TECHNICAL NOTE

Project Title: Beane Solar Farm

Report Reference: 794-PLN-TRP-JNY11727-04

Beane Solar Farm Technical Note

Figure 1: Traffic Management Between the Northern and Southern Parcels for Construction Vehicles

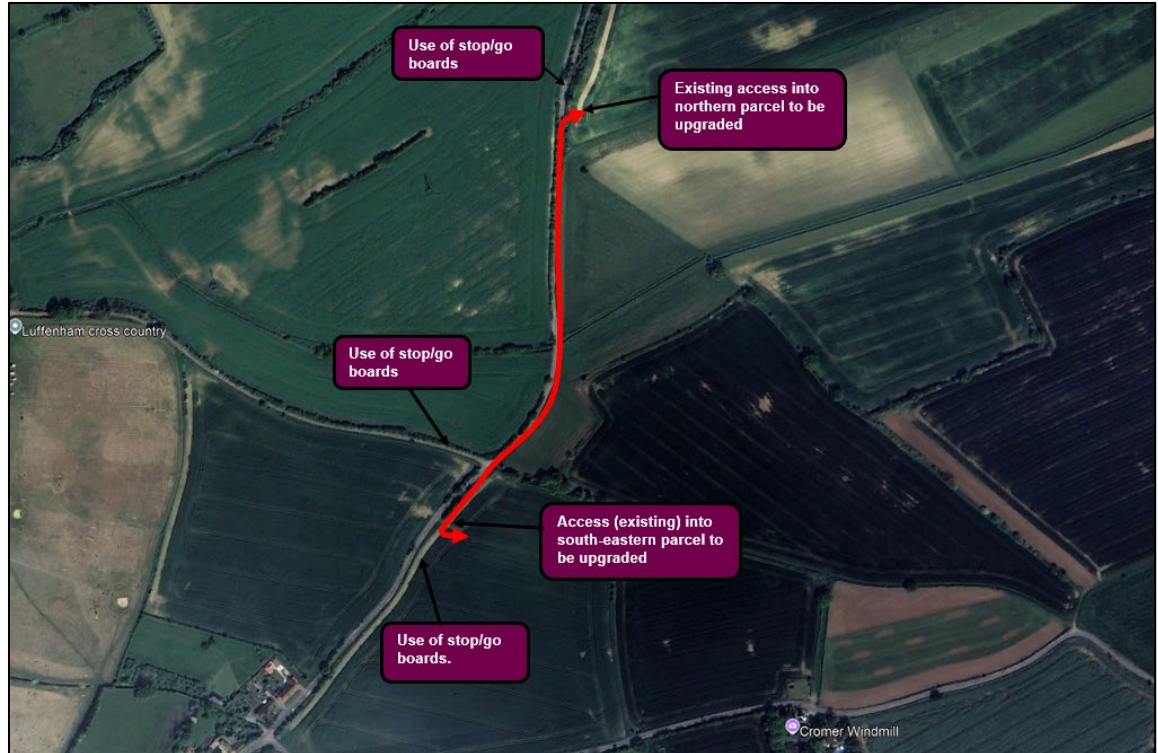
“- Extra information is needed on the use of stop/go boards including frequency, times they will be used, is there a proposal to hold traffic, how will operatives communicate?”

- If accepted the use of stop/go boards will require an approved permit from the HA.”

- 1.16 Bankspersons will be situated at both accesses on Cromer Heath to assist construction vehicles in accessing and egressing the northern and southern portions of the Site. Paragraph 4.21 of the CTMP states that stop / go boards will also be utilised to hold traffic along Cromer Heath, to enable construction vehicles to travel between the Northern and Southern parcels, as shown on **Figure 1**.

- 1.17 The stop / go boards arrangement will be deployed in accordance with Chapter 8 of the Traffic Signs Manual (DfT / Highways Agency, 2009). Bankspersons will radio to the other bankspersons on site to coordinate the movement of construction vehicles along Cromer Heath.

- 1.18 It should also be noted that all construction work will be conducted between 08:00 and 18:00 hours Monday to Friday with limited construction activities on Saturdays between 08:00-13:00, as stated in paragraph 2.9 of the CTMP. The stop / go boards arrangement would only be deployed when a construction vehicle needs to travel along Cromer Heath during these hours. A permit will be obtained from HCC by the Principal Contractor.

- 1.19 The configuration and management of the Cromer Heath crossing will manage the potential conflict between users of the highway and construction vehicles travelling along Cromer Heath, by preventing an emerging HGV crossing from one portion of the construction site to another, if a vehicle is travelling along Cromer Heath.

Appendix 3 – 17.8m Crane Swept Path Analysis

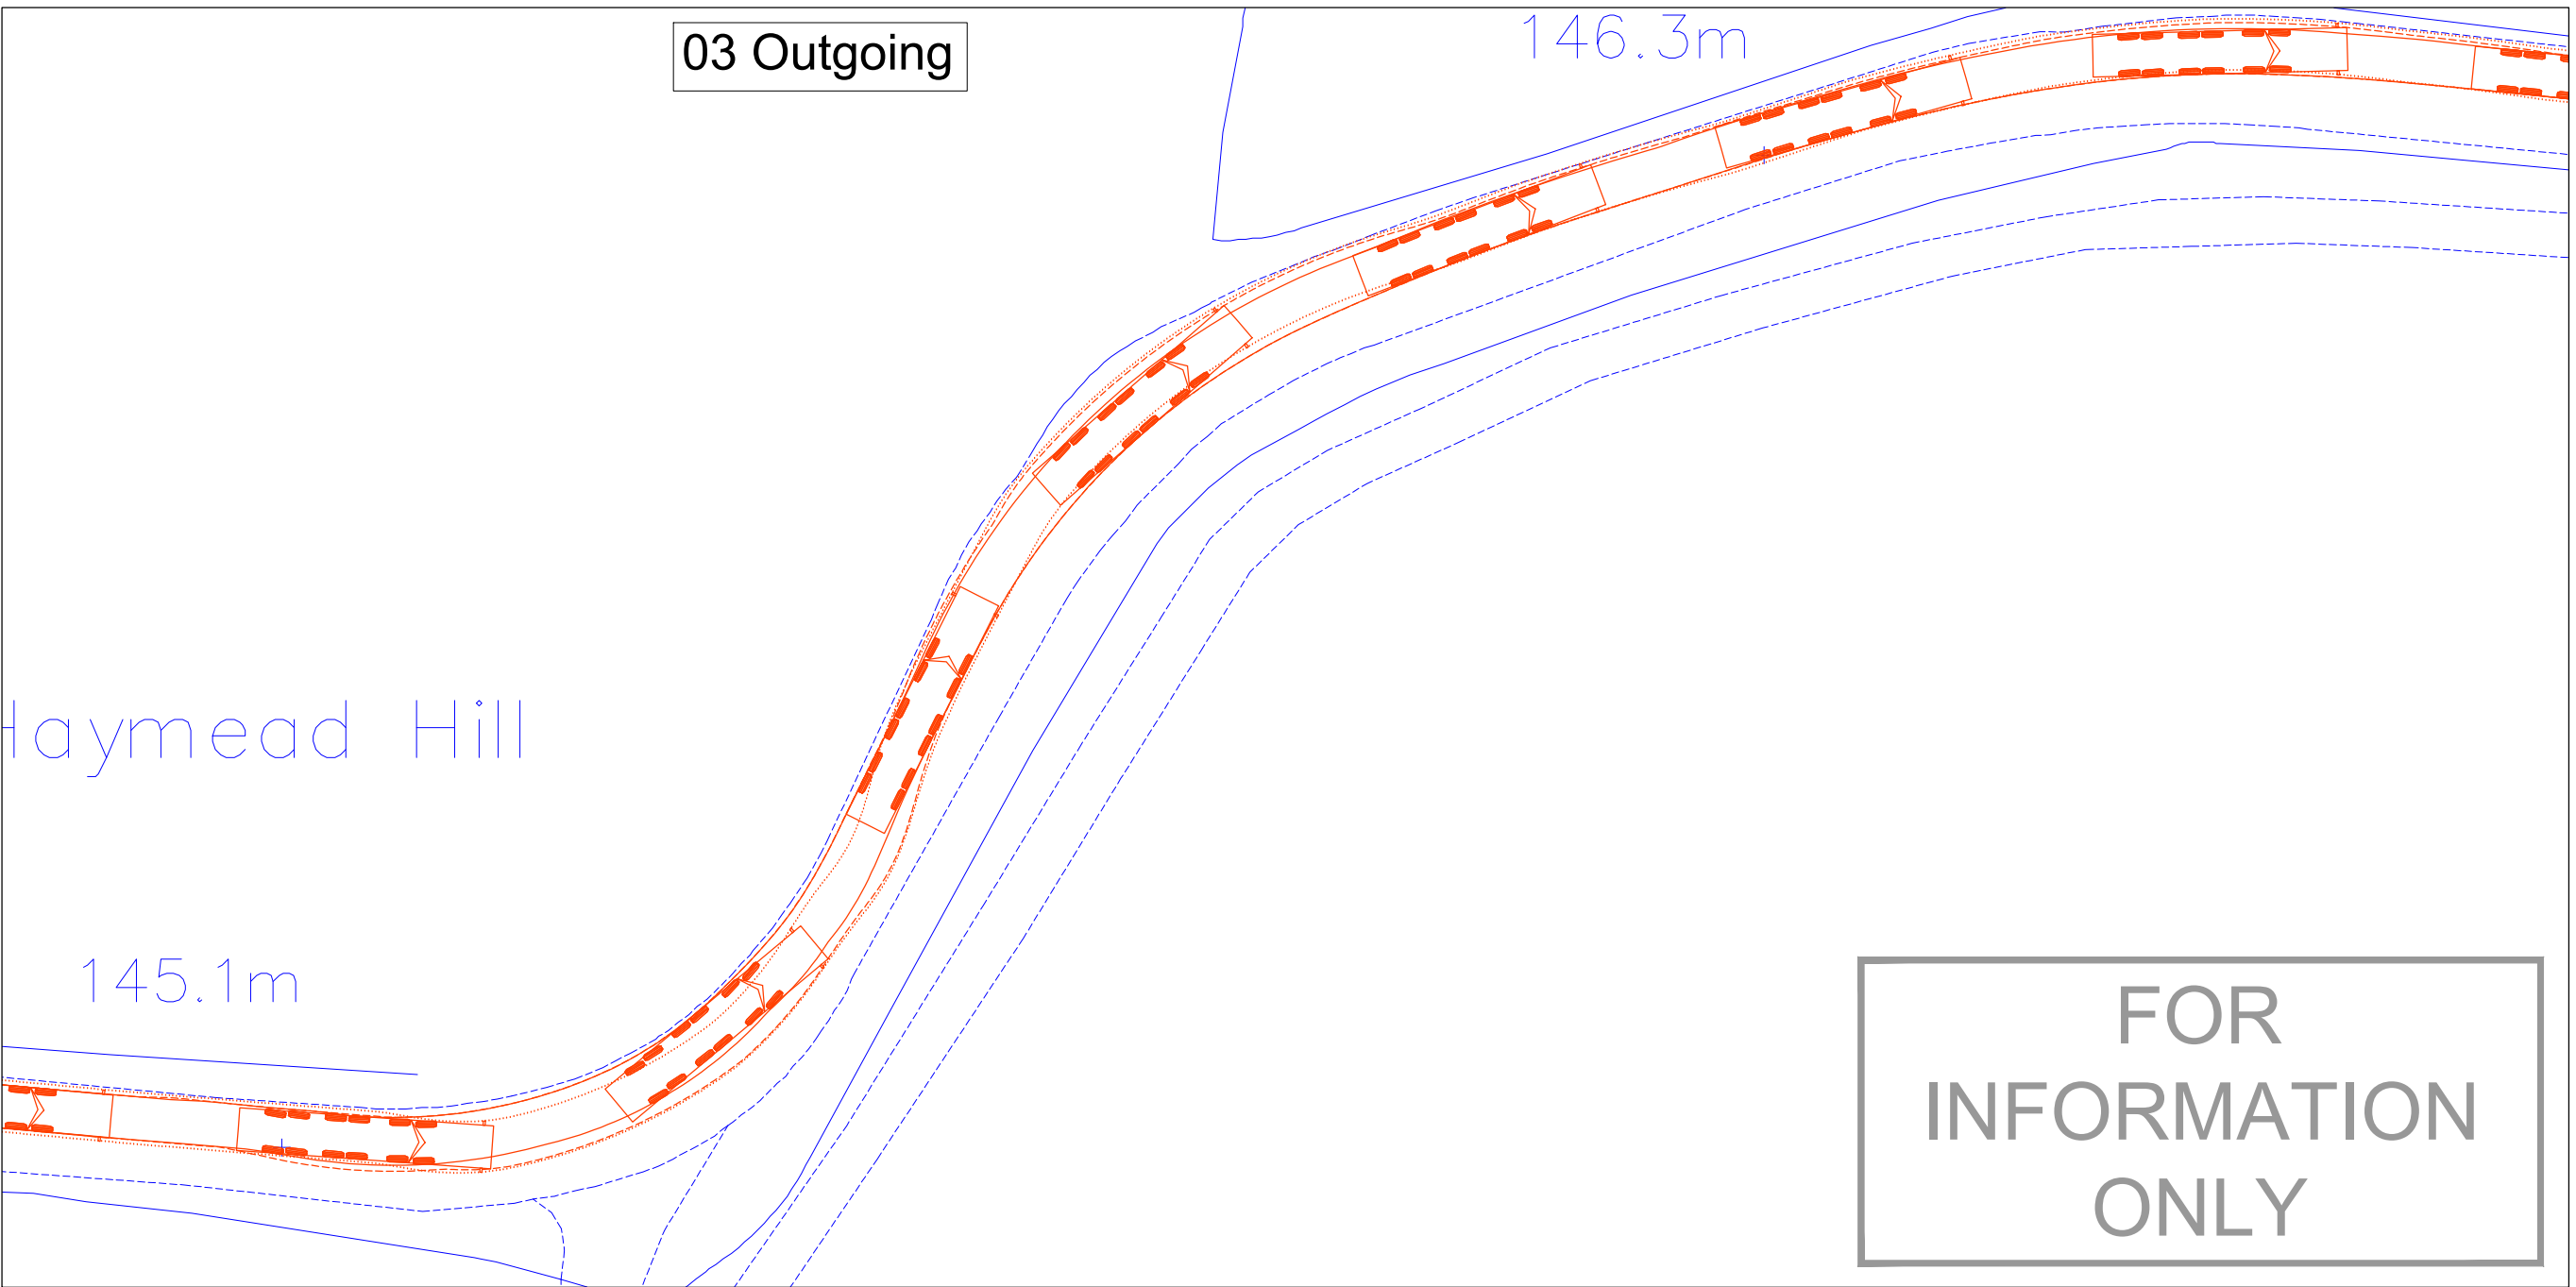
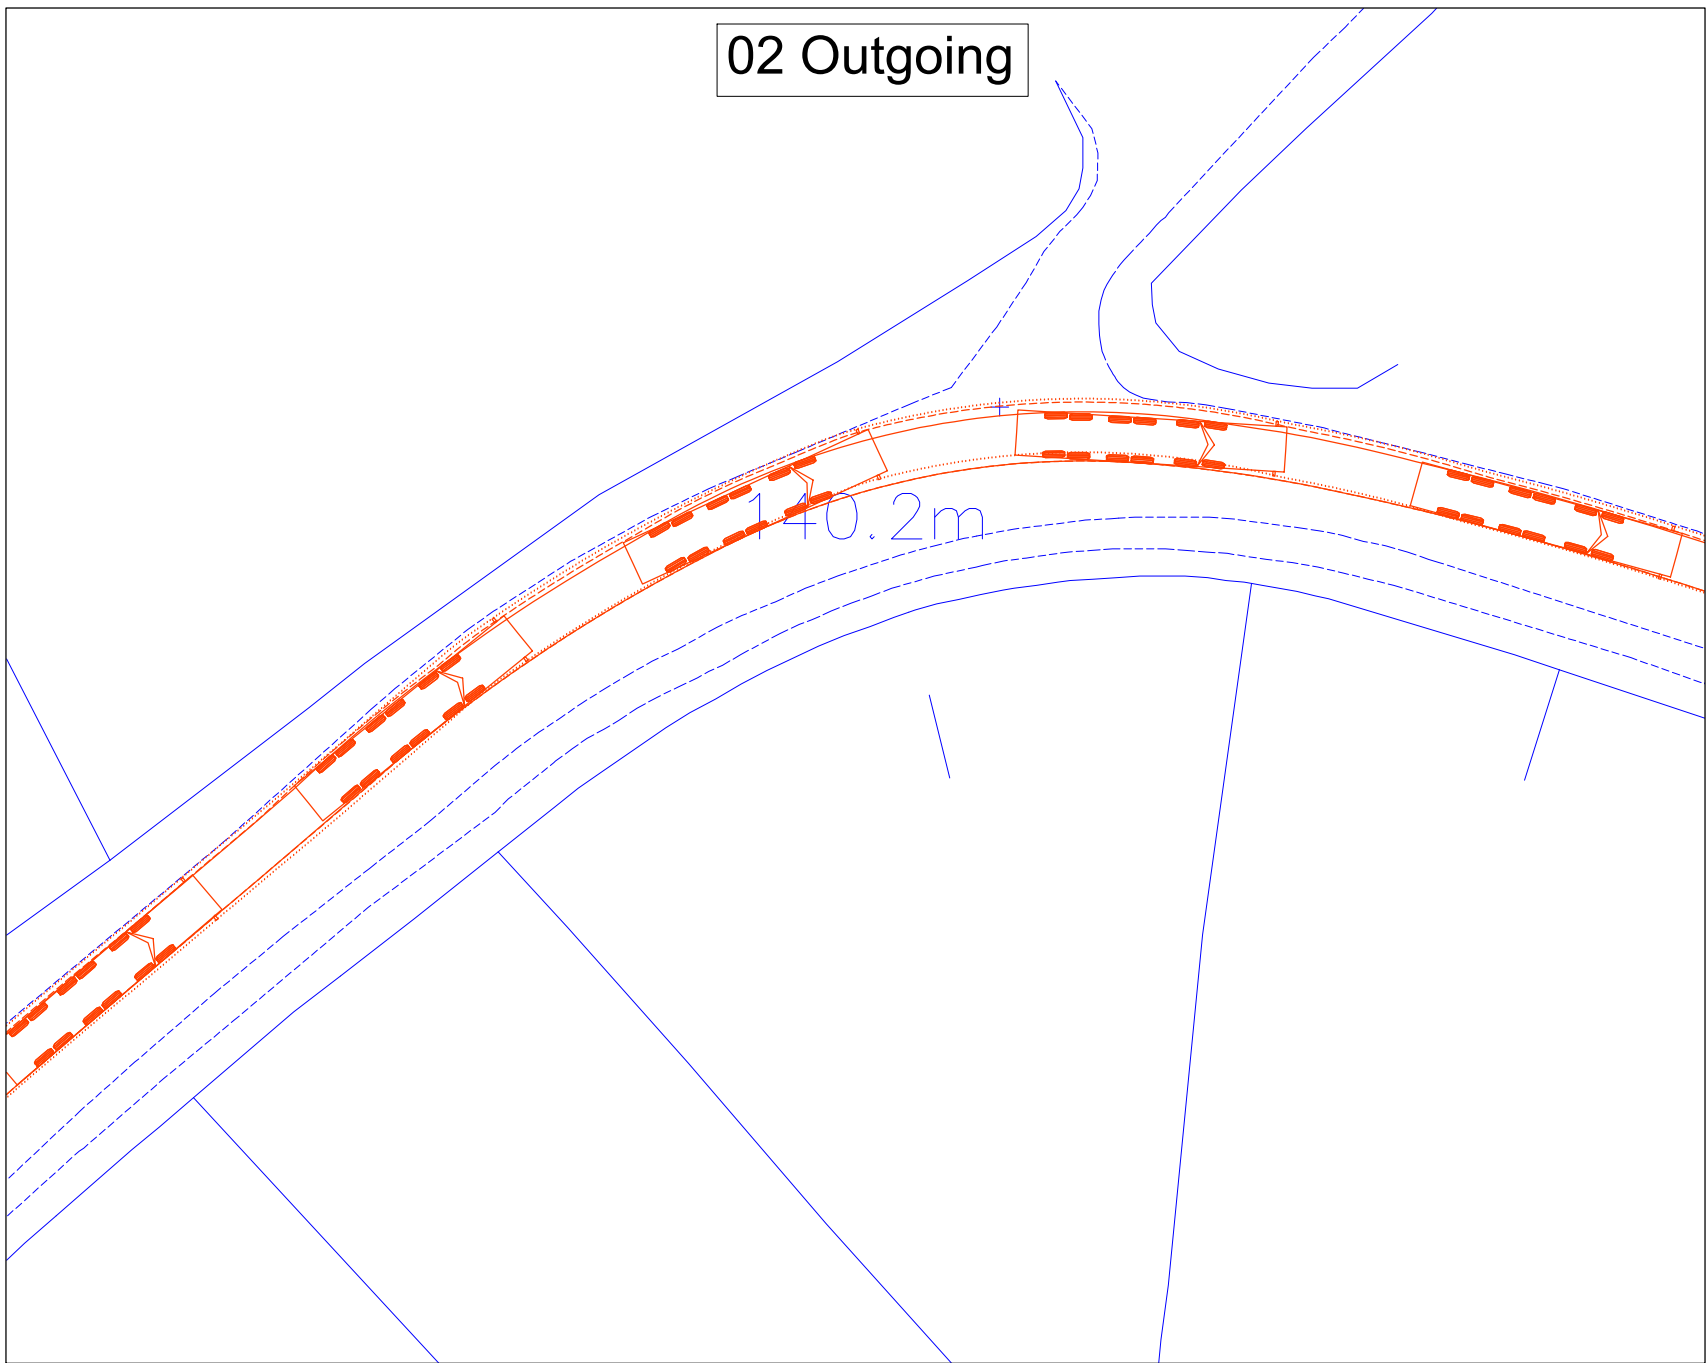
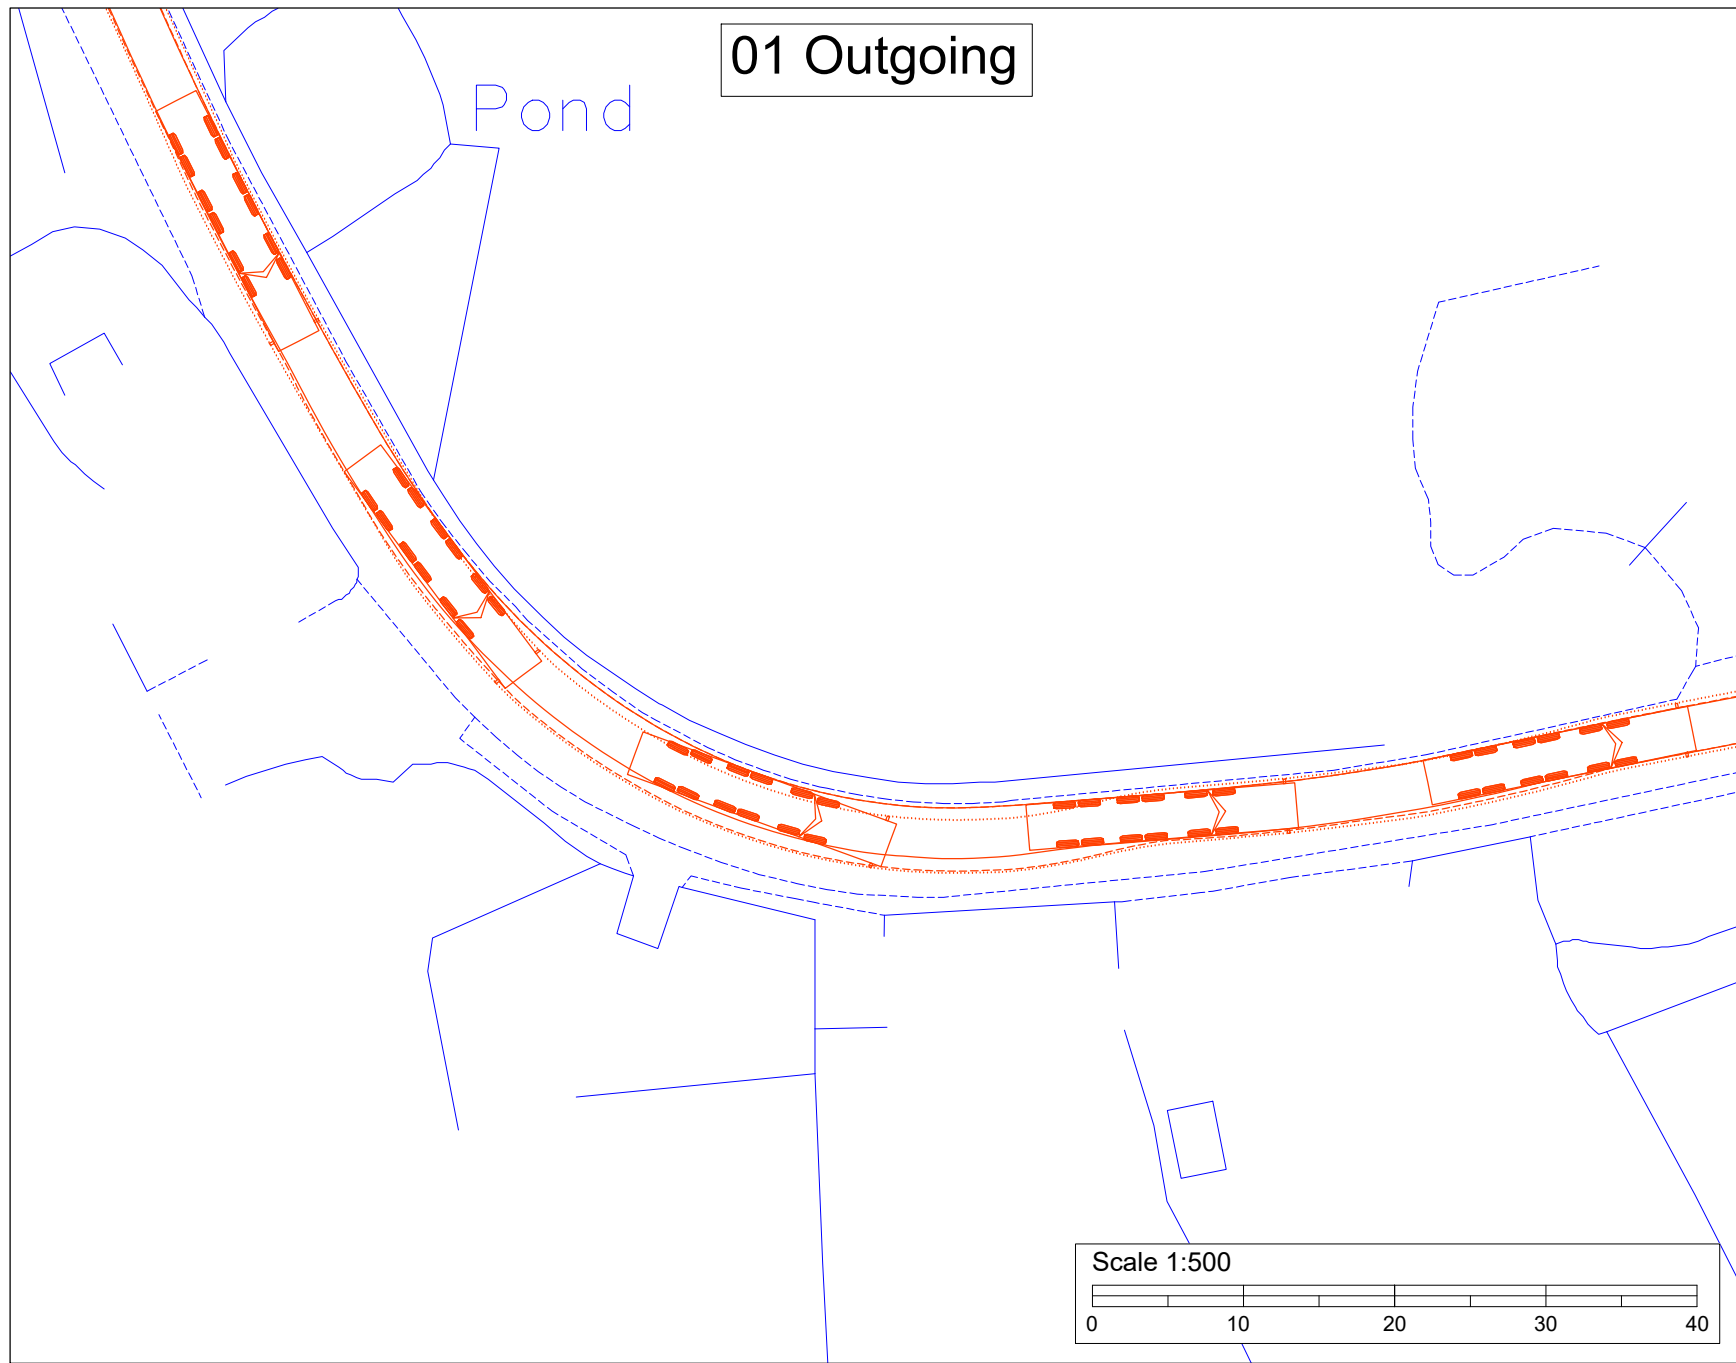
“- As per figure 3 the largest vehicle to the site will be a 17.8 metre crane which would need to be tracked using a swept path to ensure that it can reach and access the site.

- 1.25 A swept path analysis has been undertaken of a 17.8m crane accessing the site from the east via the A10, as this is the shortest route on the A507 of approximately 5.2km and a signposted route to the A10. This route also avoids Baldock to the northwest of the site. The swept paths are attached at **Appendix 3**, which demonstrate that a crane can travel safely along the proposed access route.
- 1.26 There will only be one entry movement, and one exit movement, of a vehicle of this size during the construction period.
